Coastal Texas Protection and
Restoration Feasibility Study
Final Feasibility Report

Appendix D – Annex 16:
Anchorage
Memorandum for Record (MFR)

SUBJECT: Coastal Texas Project: Anchorage Area

Figure 3(a) – Proposed New Anchorage Area Footage by the Anchorage Working Group

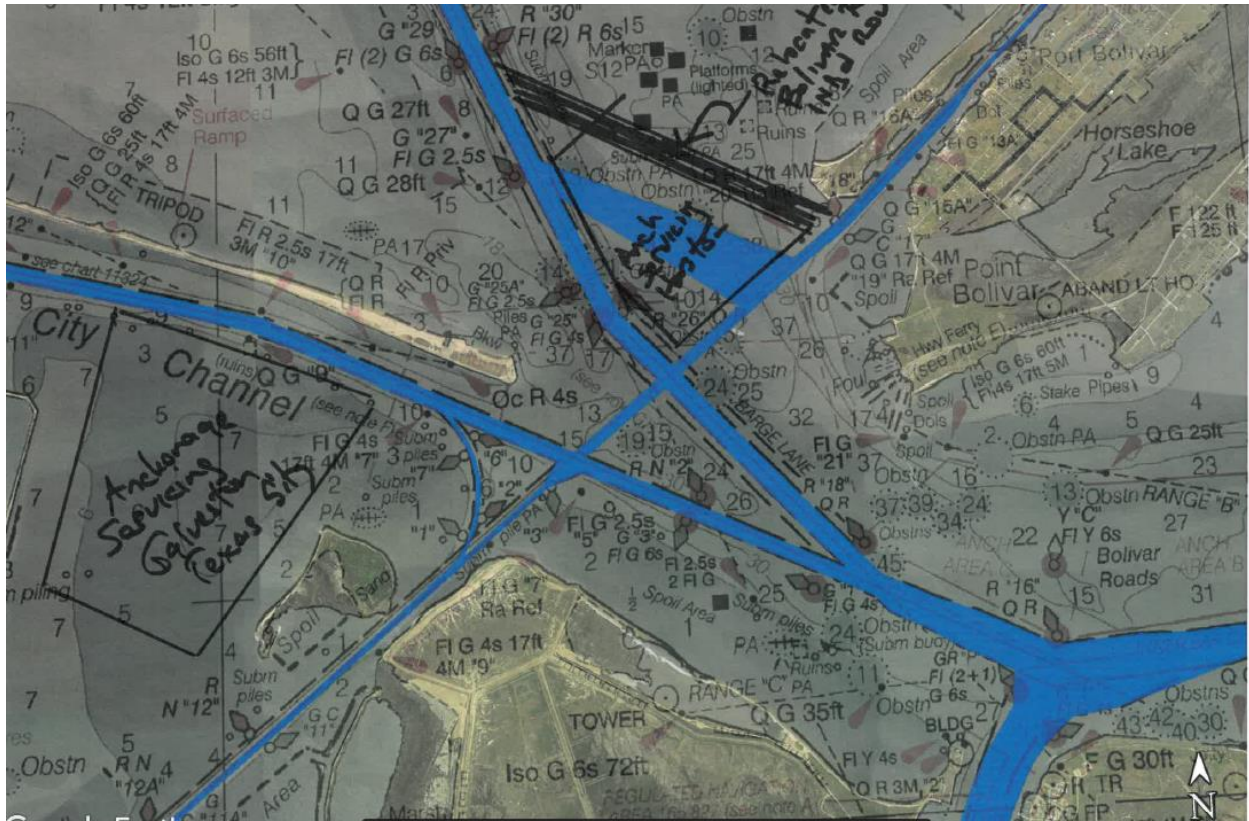
Proposed anchorage behind Pelican Island - has the potential for hypoxia issues. It also eliminates the ability to create enough obstruction to force water out Bolivar Roads and not into West Bay during wrap around in-bay hurricane wind driven surge. This anchorage will likely slowly fill with fine grained sediment.

Figure 6: Modified anchorage areas and surge barrier system across the entrance channel.

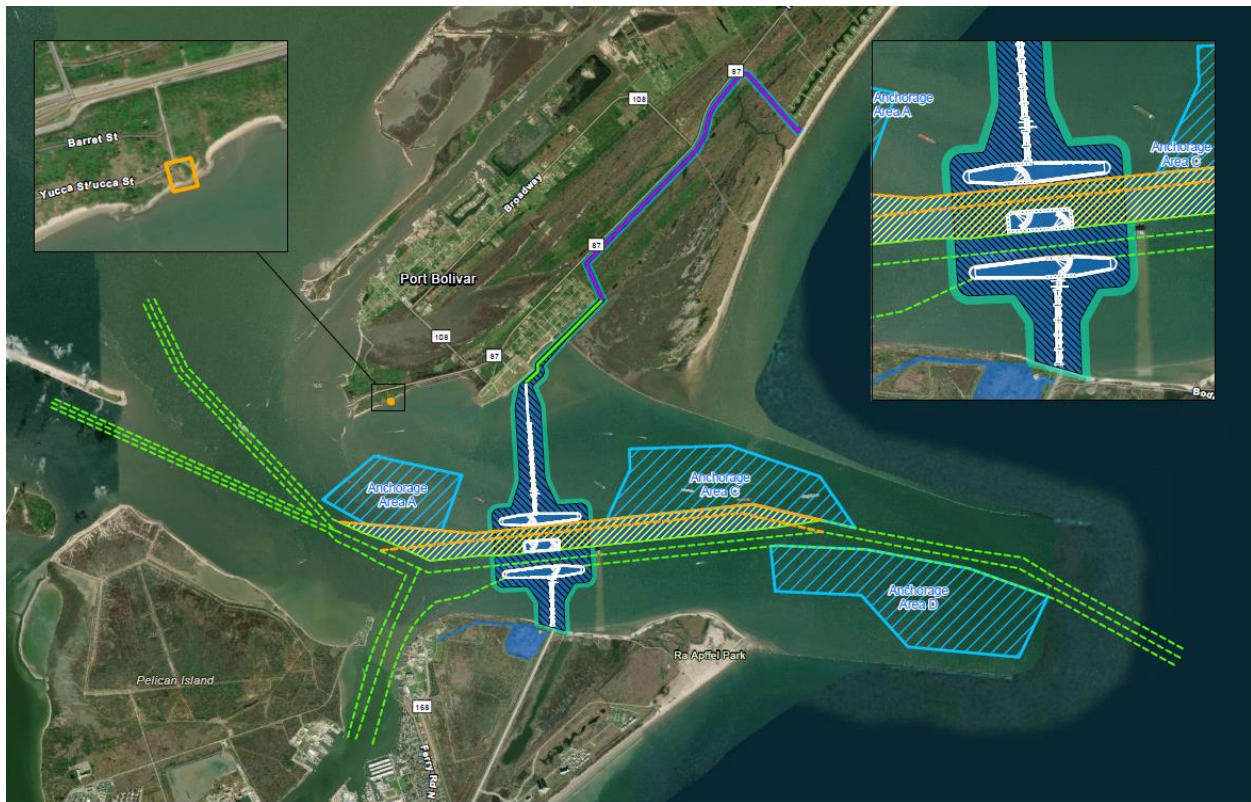
Anchorage Area 3 (D) - this location does not seem very sheltered at least on its outer extents, the sea state in this area will have to be modeled for its suitability for an anchorage.

Anchorage Area 5 - adding this anchorage area to the recommended plan seems valuable as the O&M will be likely minimal and its shelter location, adjacent to the Port of Galveston. It will likely require fixing moorings, however.

How were the anticipated shoaling rates determined for each of the anchorage areas? That is not discussed.
